September 17, 2008

In Reply Refer To: HSSD/CC-42B

Name of device: High Speed (70 mph) QuadGuard – Flared Version
Type of device: Impact Attenuator
Test Level: NCHRP Report 350 Test Level 3
Testing conducted by: N/A
Date of request: April 14, 2008

Figure 1

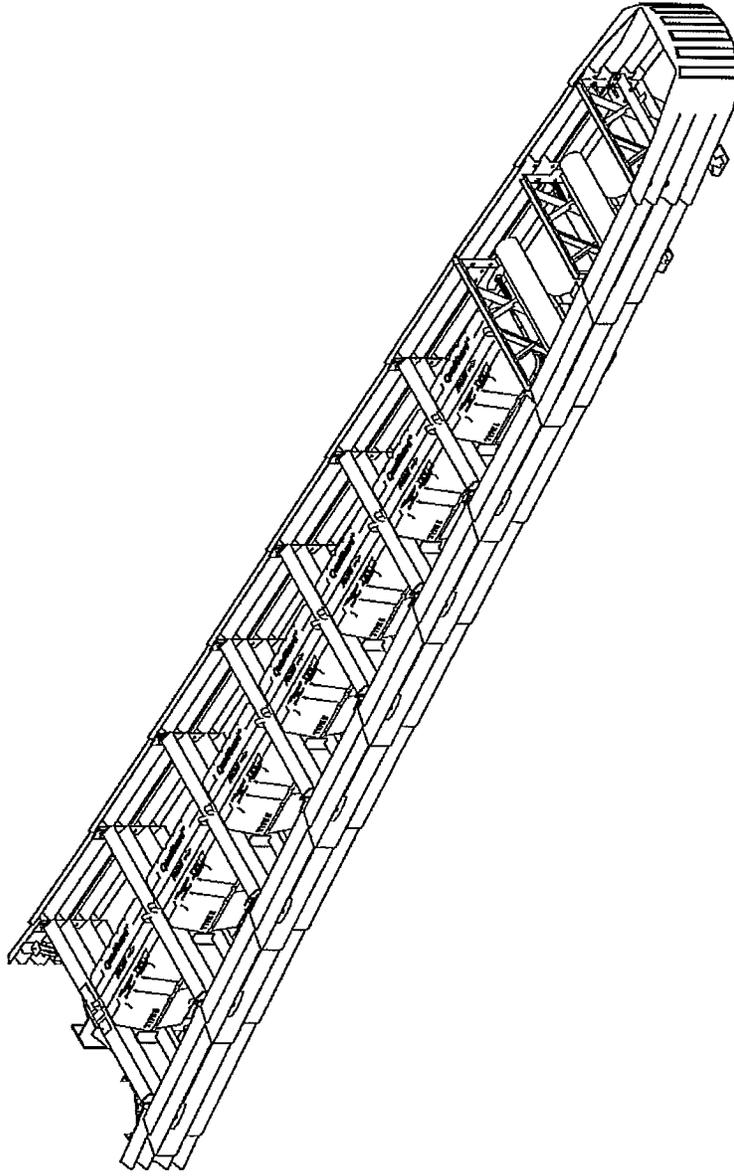
No actual crash tests were submitted for this request. Instead, results from previous successful tests of parallel-sided and flared QuadGuards (QG and QG-Flared) at TL-3 impact speeds were presented as well as tests into a parallel-sided QuadGuard high speed unit at elevated impact speeds of 70 mph (QG-HS). Using the data from those successful tests, engineering logic was presented predicting the results for similar tests into your proposed High Speed Quad Guard – Flared Version.

As a service to the highway community, FHWA finds devices meeting NCHRP Report 350 acceptable for use on the National Highway System for impact speeds up to 100 km/hr. You have shown that the QG-HS-Flared will likely meet similar evaluation criteria when tested at 113 km/hr. FHWA concurs that the device described above and detailed in the enclosed drawing is acceptable for use on the NHS under NCHRP Report 350 TL-3 conditions, when acceptable to a highway agency. Should an agency wish to specify an attenuator with capacity exceeding TL-3 the QG-HS-Flared is acceptable for use at speeds up to 113 km/hr.
